UNITED STATES
NUCLEAR REGULATORY COMMISSION
REGION III
799 ROOSEVELT ROAD
GLEN ELLYN, ILLINOIS 60137

SUBJECT: SALP III EVALUATION PERIOD

MIDLAND UNITS 1 AND 2

Major Events Ladder

CUTTING LIST		QUANTITIES	
SHEET	ANGLE		
COPY # 3 INCLOSURE			
NOT ACCORDING TO BECHTEL			
DRWG. C-898			
DETAIL 7			
ILLUSTRATION ONLY			
#31

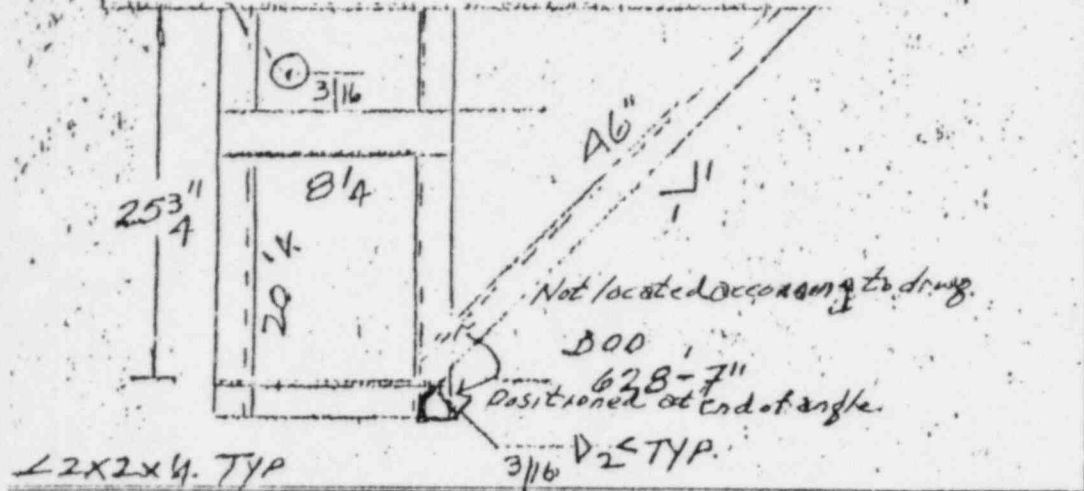
CUSTOMER HOLD POINTS **NONE** DIMENSIONAL TOLERANCES: **+ 1/4"**
 WELDING PROCEDURES: **MA-CCP 1A** **IPCCB**
 NOT ACCORDING TO BECHTEL
 DRWG. C-898
 DETAIL 7
 NOT POSITIONED EXIST. ST.
 ACCORDING TO DRWG. (I-BEAM)

NOT ACCORDING TO BECHTEL
DRWG. C-898
DETAIL 7

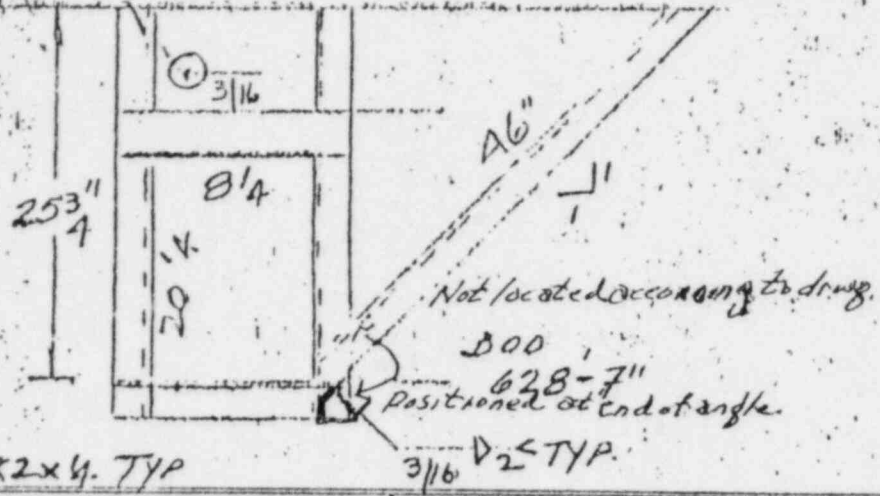
NAT POSITIONED EXIST. ST.
ACCORDING TO DRWG. (I-BEAM)
